DEVELOPMENT APPLICATION: FIGHTING PIKE DATA CENTER
PLANNER: City of Williston/SRF Consulting Group

INTRODUCTION

This staff report provides a review and recommendations regarding the development proposal for the Fighting Pike data center complex. The staff report is organized as follows:

Figure 1. Preliminary Site Plan

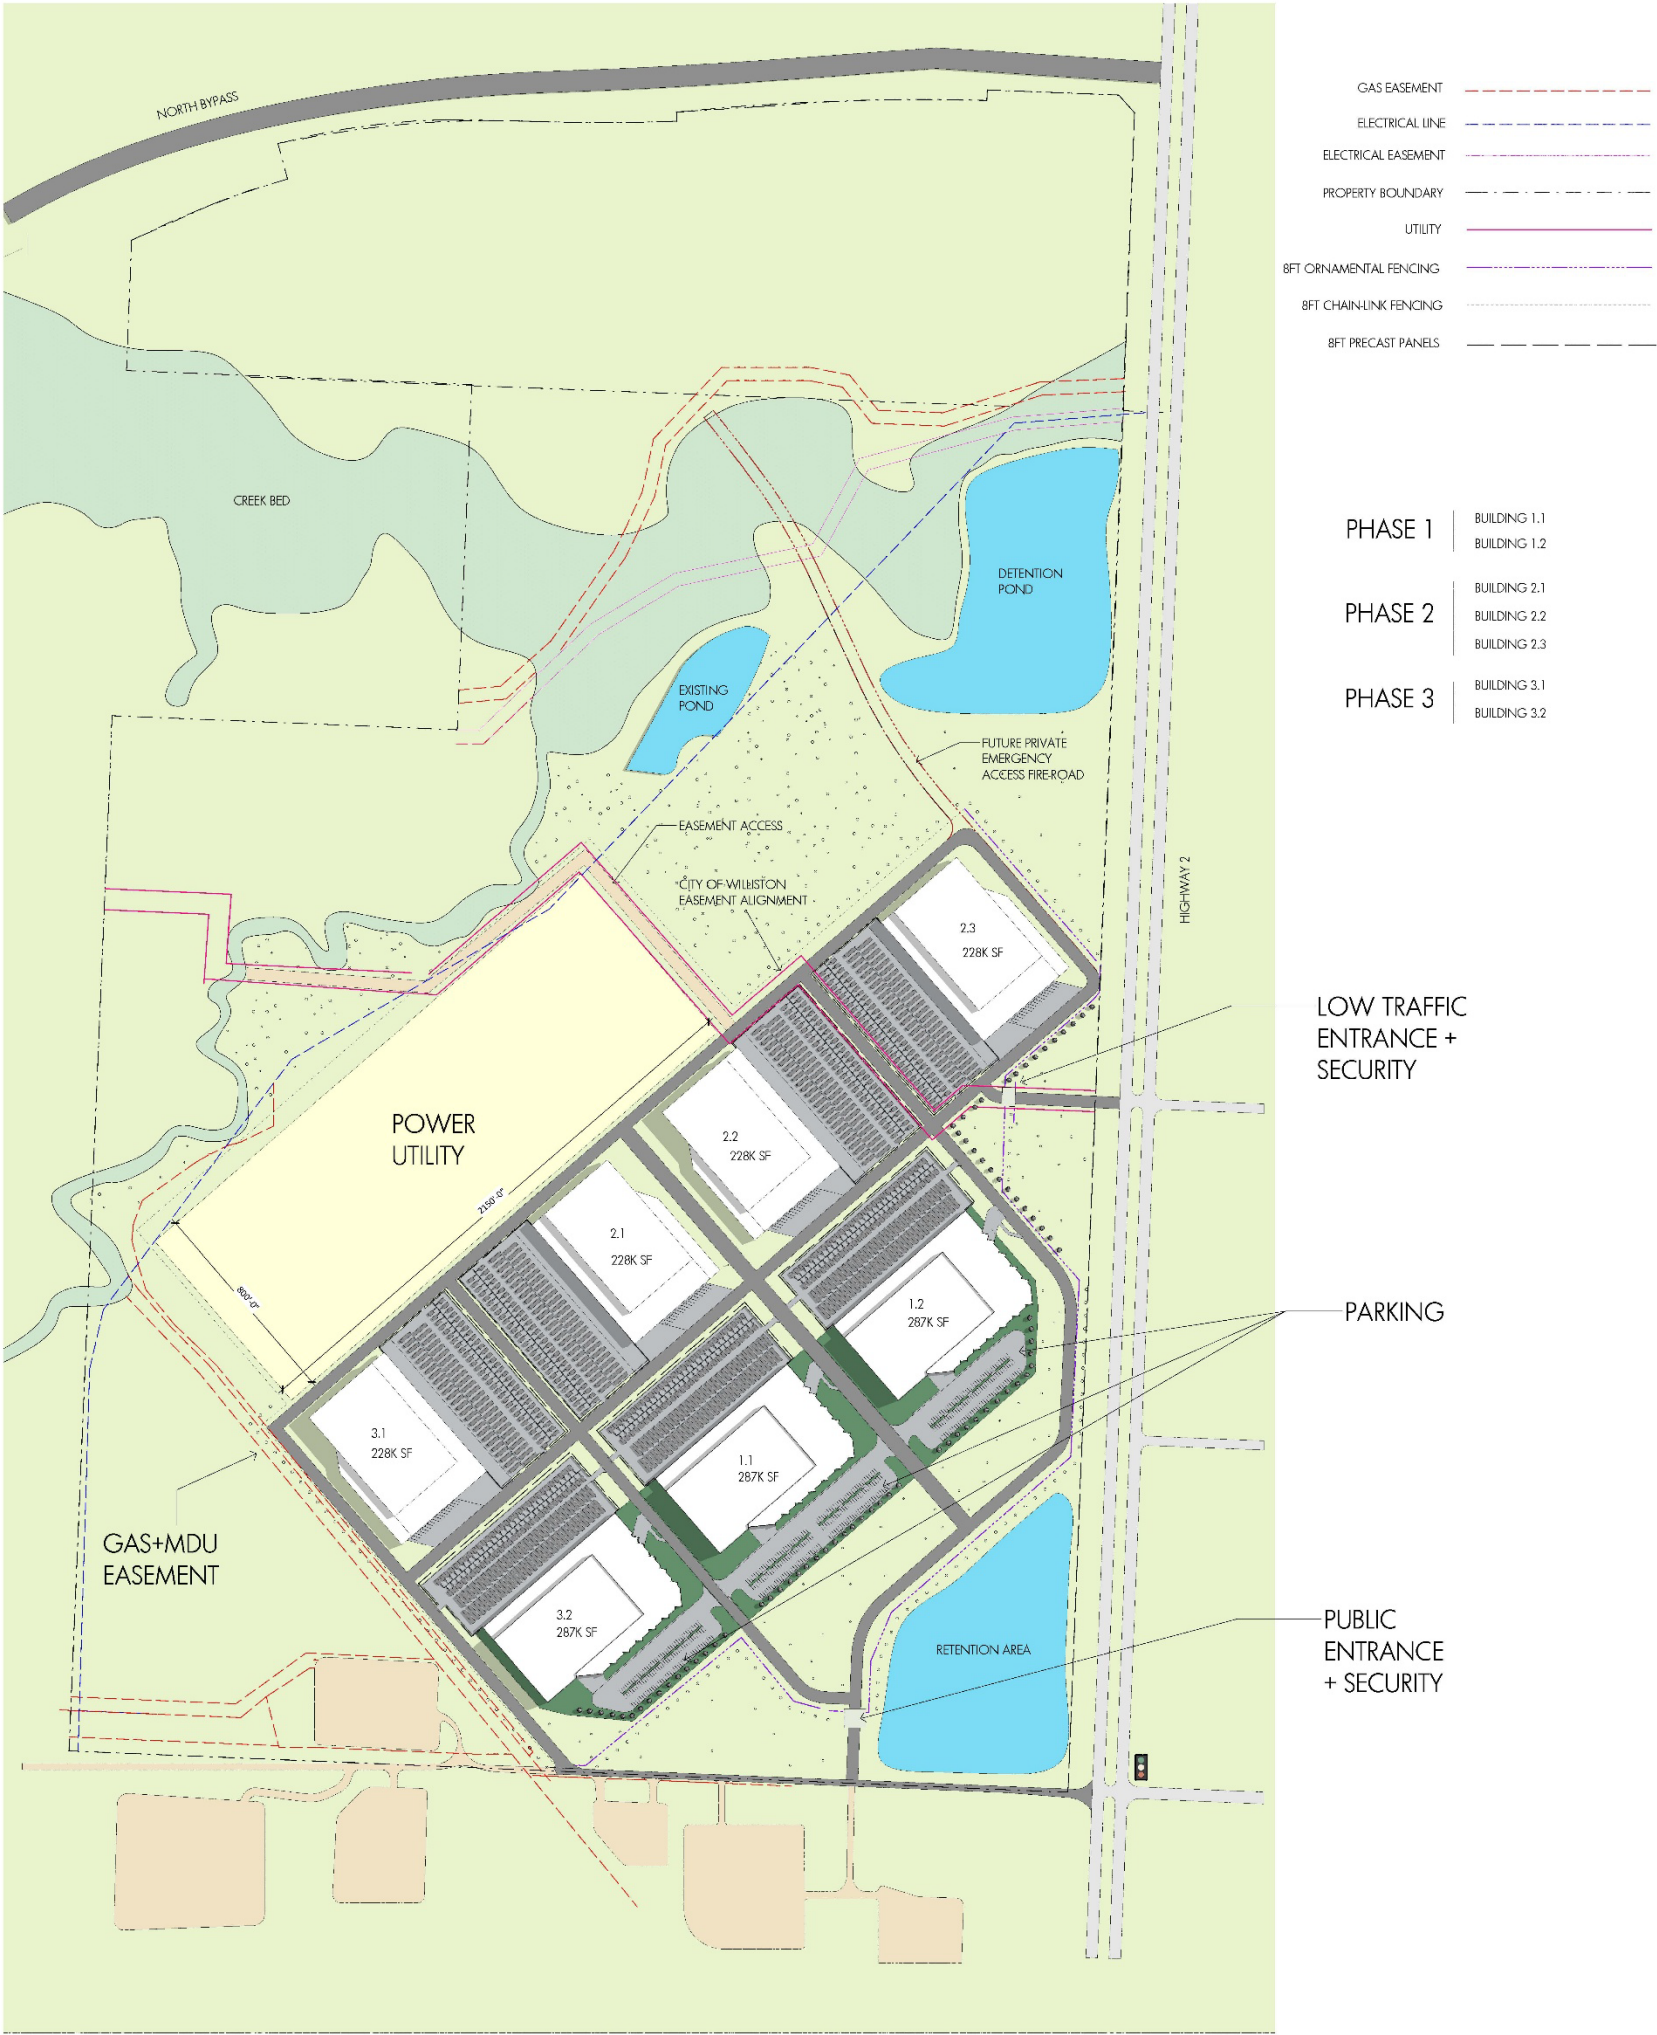
Figure 1 on the following page shows the Preliminary Site Plan. The Site Plan indicates proposed buildings, roads, landscaping, and other elements of the development at buildout, which are discussed in detail throughout this report. The data center complex will be located on Lot 2 of the Northstar Center Subdivision Rearrangement #1. (See Section 5. Preliminary Plat for a detailed review of the proposed subdivision.)

It is important to maintain connectivity and development potential for Lot 1, while ensuring security for Fighting Pike, as desired by the applicant. The site plan shows a conceptual alignment for a "future secondary access road," which would be needed to provide secondary access to Lot 1, as NDDOT and City staff do not support additional access on US 2 between Energy Street and the US 85 Bypass. This will be conditioned as a municipal and utility access easement on the plat. The Camp Creek crossing would align with the original crossing location for Northstar Parkway. The primary access to Lot 1 would have to be via a future road connection to the US 85 Bypass, which could tie in at the connection originally planned for Northstar Parkway.

The site perimeter will be fully fenced to a height of 8 feet. Ornamental fencing (e.g., semi-transparent metal) would be placed along the frontage road. Chain link fencing would be used for the remainder of the site. Fencing transition points are indicated on the site plan.

Parking areas are indicated on the site plan. Parking stalls are provided based on expected employment for the different buildings. A greater amount of parking is needed and therefore shown for the buildings on the east side of the development; this is primarily due to the office/administrative function of those buildings. Buildings to the west only need parking for servicing needs.

Figure 2. Site Access at Energy Street

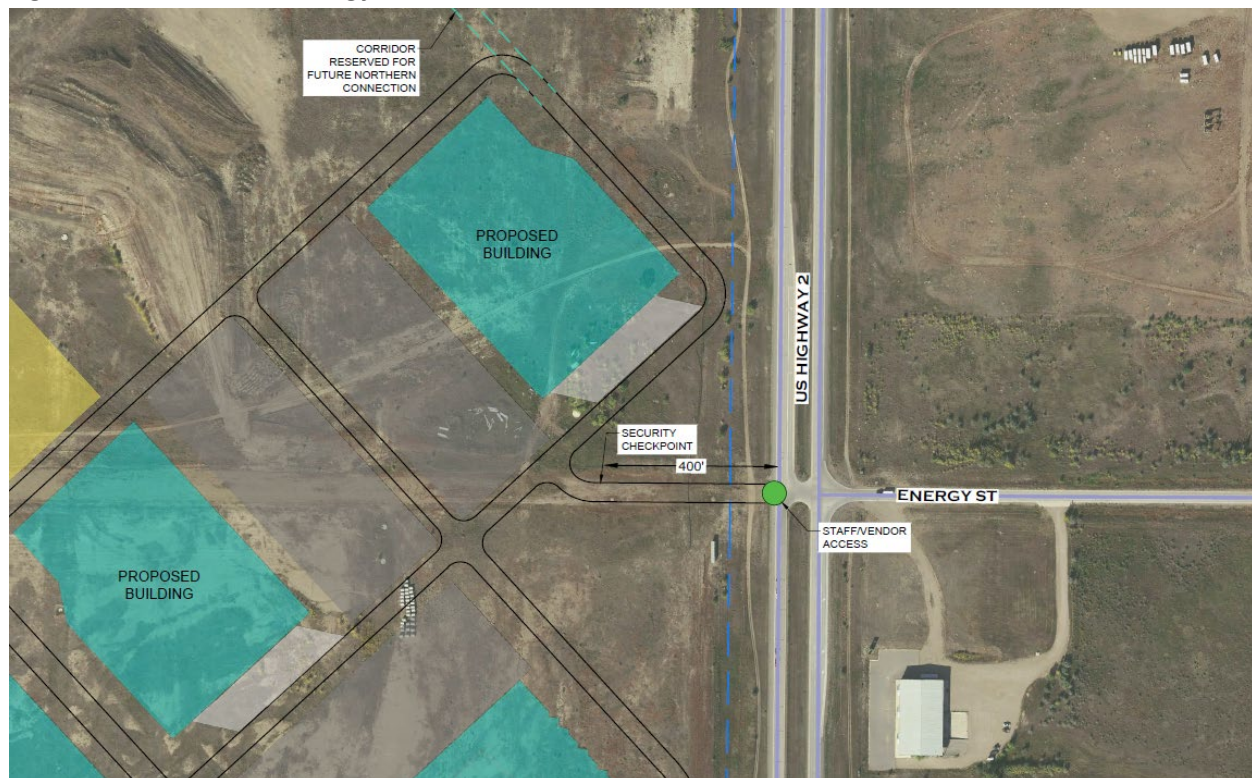
NDDOT and City staff have worked with the applicant to ensure that each access point to the site provides for adequate queuing to avoid any conflicts with US 2. The site access at Energy Street is the closest to US 2. The applicant has provided a schematic (**Figure 2**) indicating a 400' distance from the site's security checkpoint to US 2, which will be adequate to accommodate any excessive queuing (for errant trucks or site deliveries, for example).

4. A south-bound right turn lane on US Highway 2 shall be installed by the developer at Energy St. The right turn lanes shall be constructed according to Chapter III-03.05.01 of NDDOT's Design Manual. At minimum the turn lane shall have 180' long taper and 430' deceleration length. The turn lane shall be complete and pass NDDOT inspection before any vertical building or structure construction.

Figure 3. Noise Study Receptor Locations

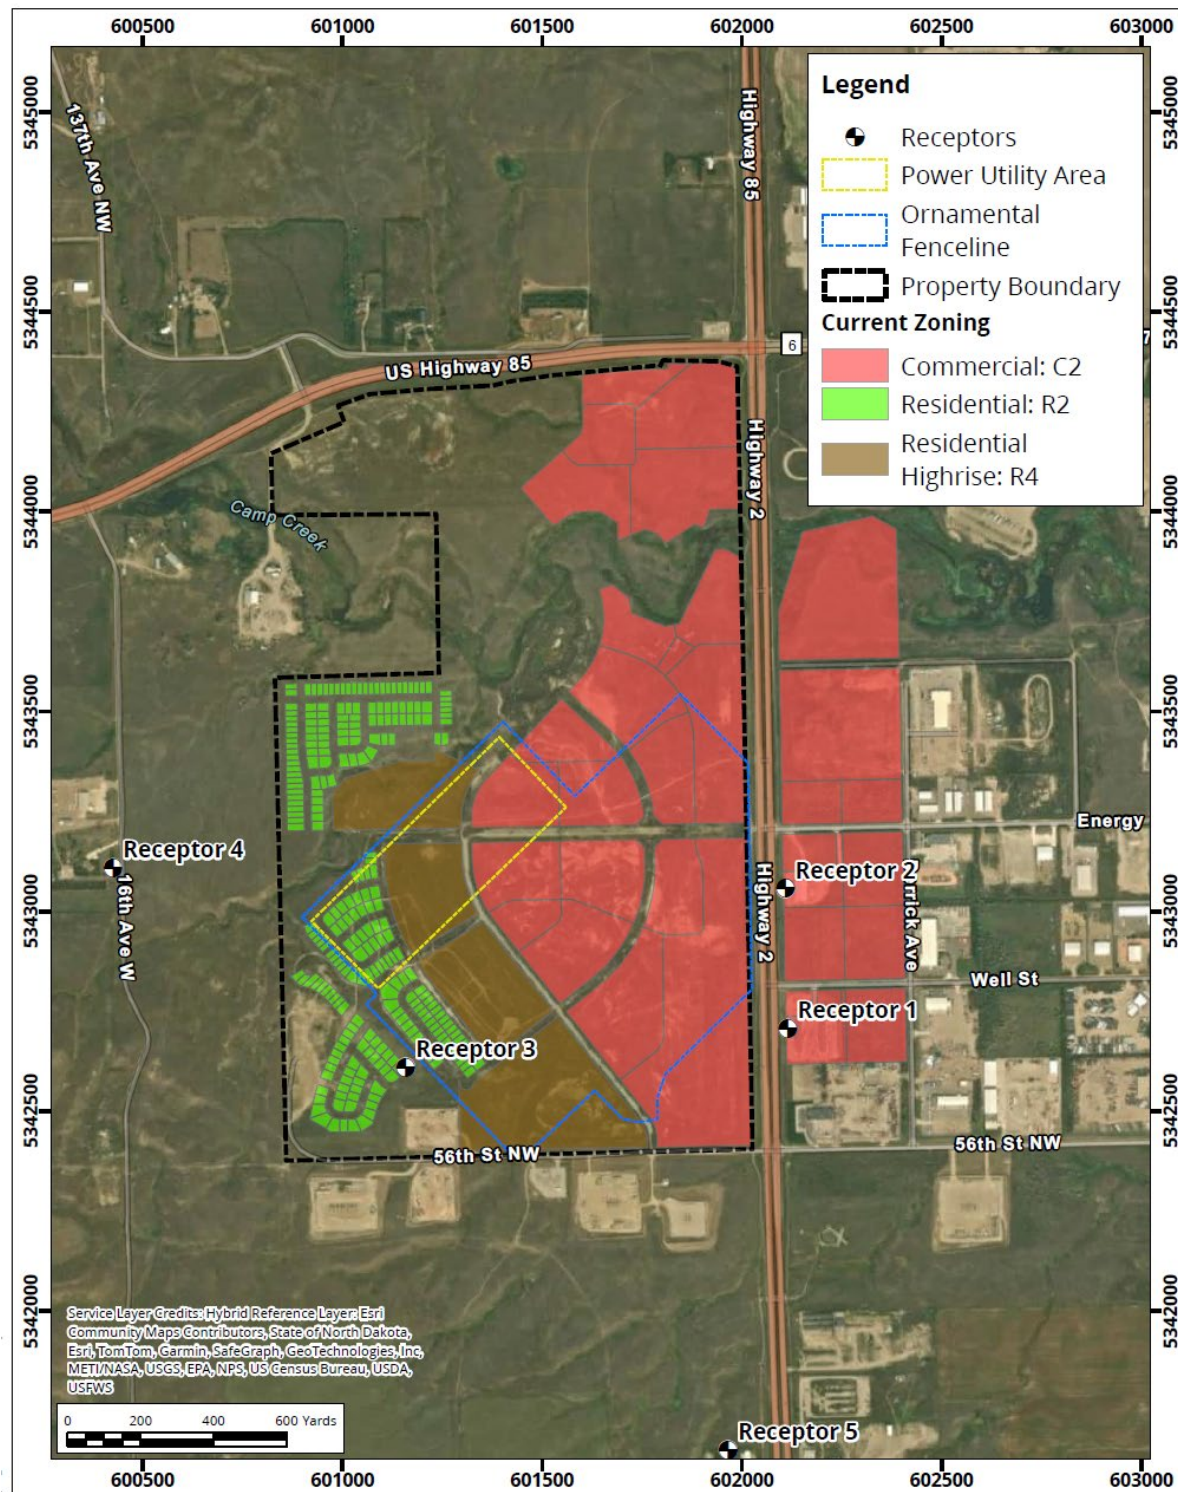
Noise impacts were modeled at five receptors, as displayed in **Figure 3**. A receptor is a land use that is considered sensitive to noise impacts, such as residential. Note that the NIA references the original PUD for Northstar Center Subdivision, which included plans for a mix of residential and commercial uses. There are no existing uses within the property boundary. In addition, Receptor 3 is located on site. While

it is informative to know noise levels near the source, noise impacts to non-participating properties are the primary concern.

Figure 4. Proposed Roadway System and Land Use Changes

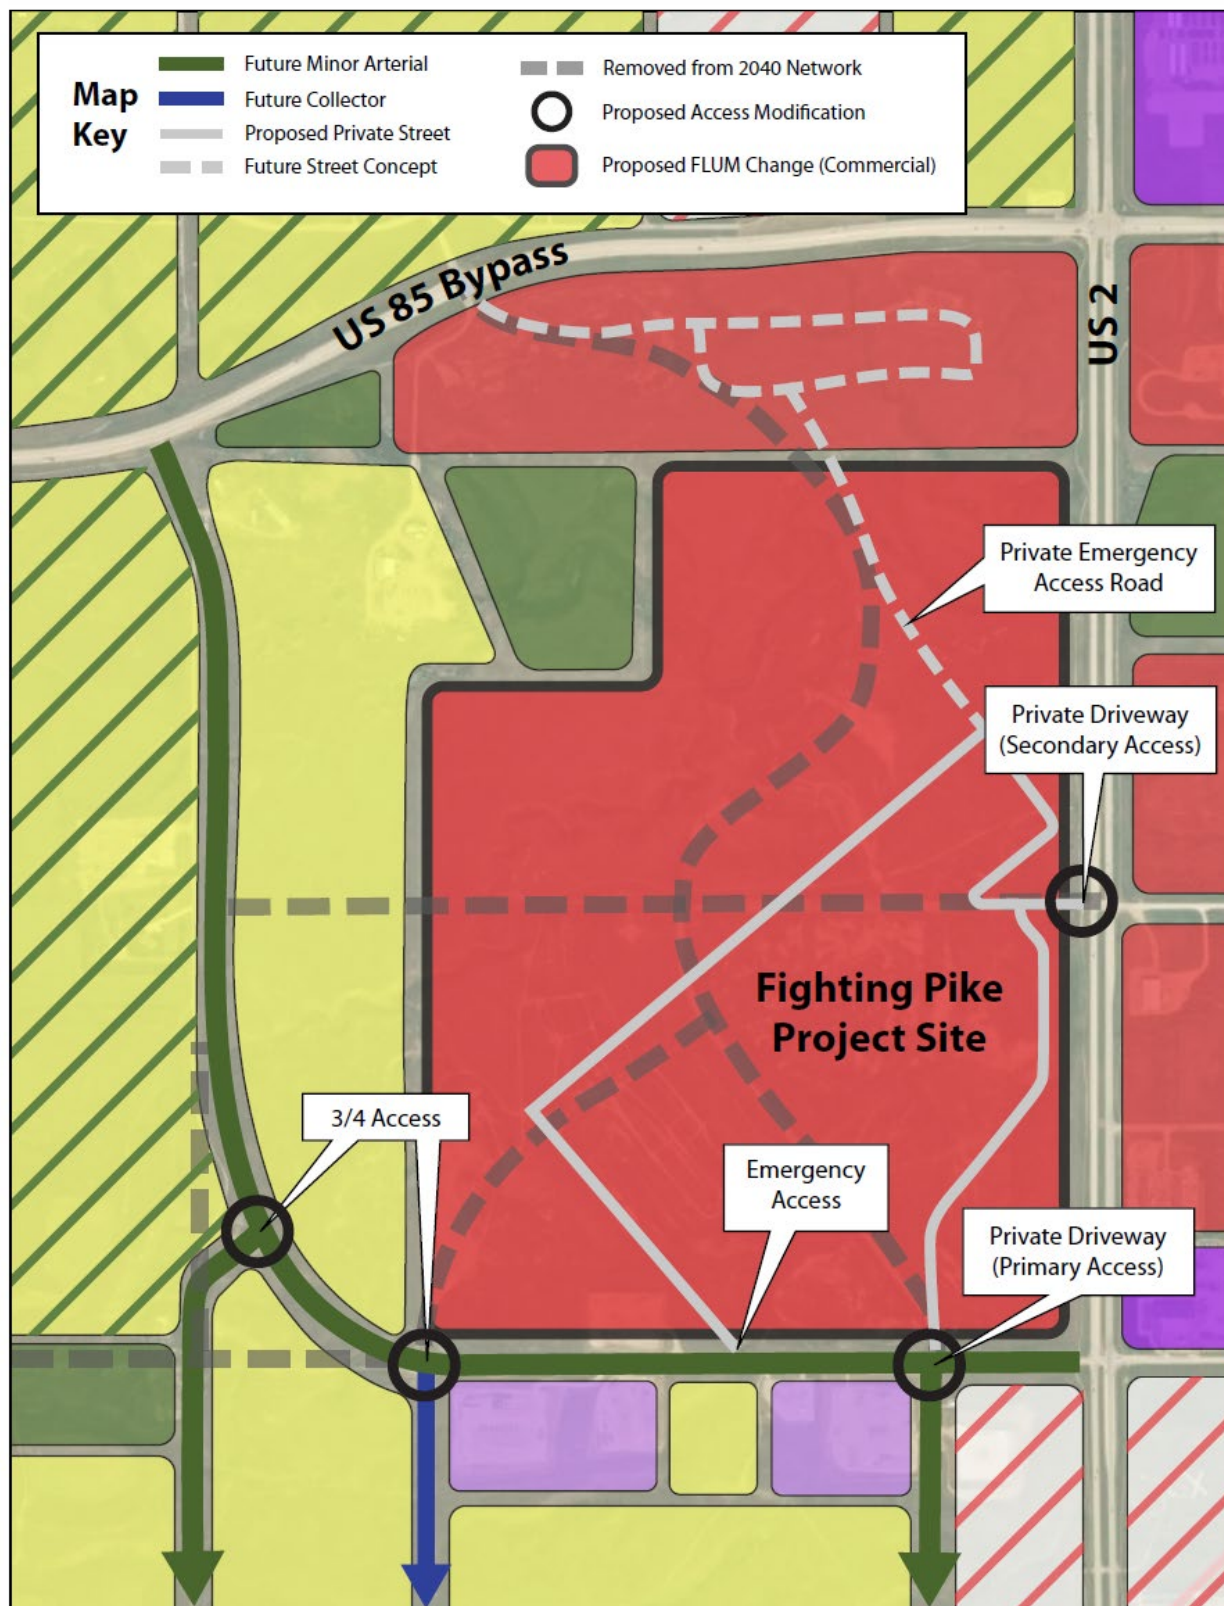
The planned alignments for several arterial and collector roads must be amended or eliminated to accommodate the project. Figure 4 illustrates proposed changes to the functional classification system, overlaid with the developer's street plan and conceptual alignments to serve adjacent properties. These changes include:

- **Route 4 – Northstar Collector (N/S).** Removal of 0.50 miles of the proposed collector from 84th Street W to Route 1 (formerly Northstar Parkway). The right of way for this section will be vacated with the Northstar Center Subdivision Rearrangement.
- **Route C – 137th Avenue NW.** This route will be realigned with the 84th Street W extension NW to form a continuous connection from US Highway 2 to the bypass.

Figure 4 on the following page summarizes proposed amendments to the Future Land Use Plan and the 2040 Functional Classification System. It also includes the street system plan for Fighting Pike and conceptual alignments for future street connections. Local street connections do not have an impact on the Transportation Plan but must be considered to ensure that surrounding parcels retain their development potential.
